Cc: randallleach@embarqmail.com; Martin D. Chapman **Subject:** BAR Action- August 18, 2015 - 700 Harris Street

BAR 15-07-03 700 Harris Street Tax Parcel 35013200 Randall Leach, Owner/Martin Chapman, Applicant Canopy replacement

CITY OF CHARLOTTESVILLE BOARD OF ARCHITECTURAL REVIEW STAFF REPORT August 18, 2015

5mbw 700 Harris Street
Proposed Restoration of Existing Entry

Proposed New Entry Door

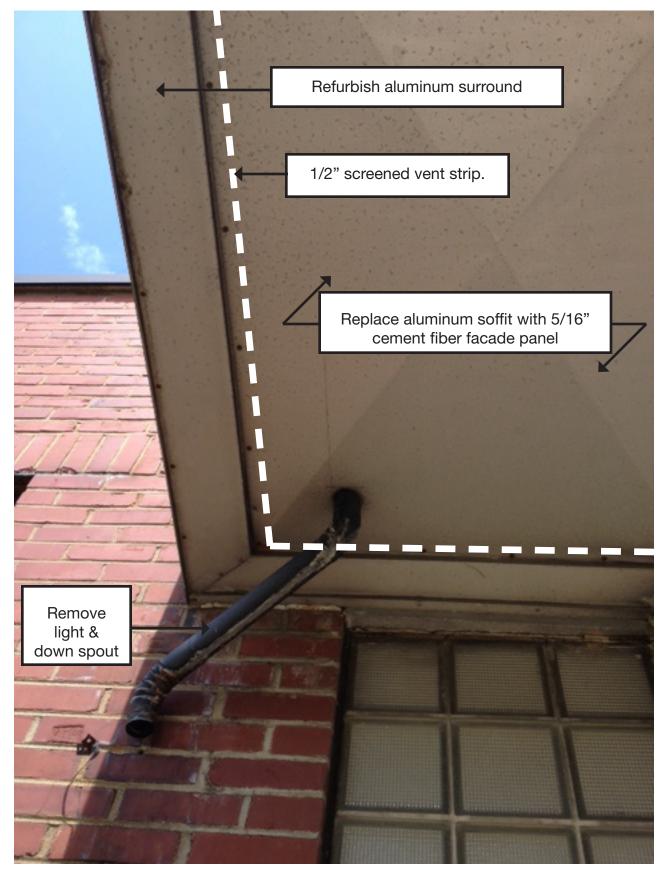
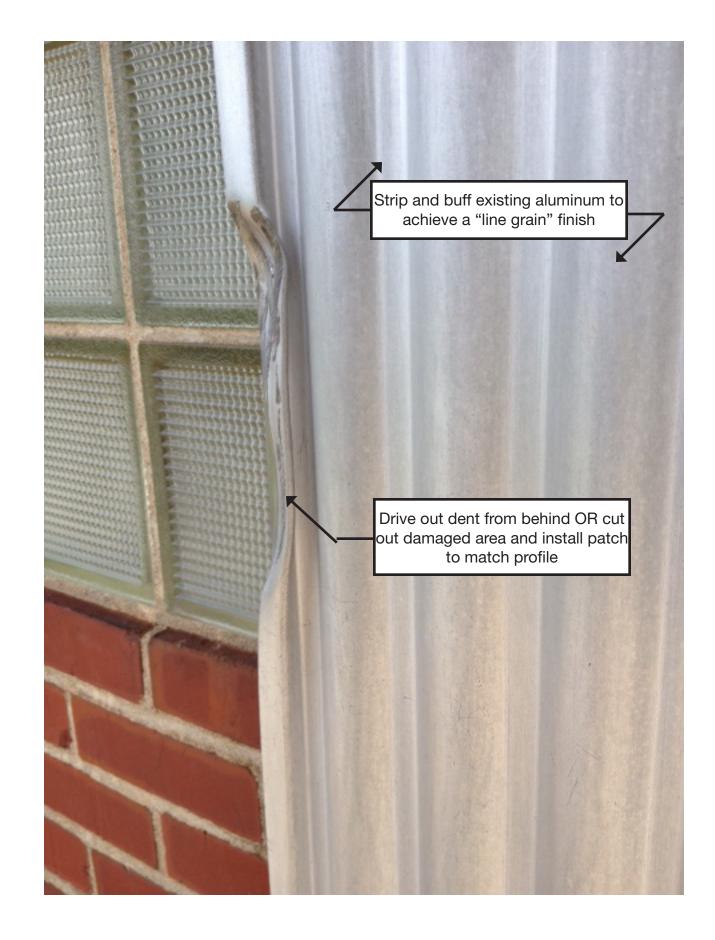
The door needs to be reworked to swing out for egress and accessibility requirements. In doing that the Owner will want to go with a more minimalist modern door with more glass. Under that

August 2015: At the July meeting the applicant requested to replace the canopy and entry components. The BAR was not supportive, so the matter was deferred. Now the applicant's plan is to rehabilitate the entry. The applicant will bring information to the meeting, but the plan is to repair the aluminum, and to replace the glass block with similar, but clear, glass blocks. The applicant will also bring a landscape plan, stair profile, and handrail details.

The BAR approved the application as submitted (7-0) with a landscape plan to be circulated to the BAR for administrative approval.
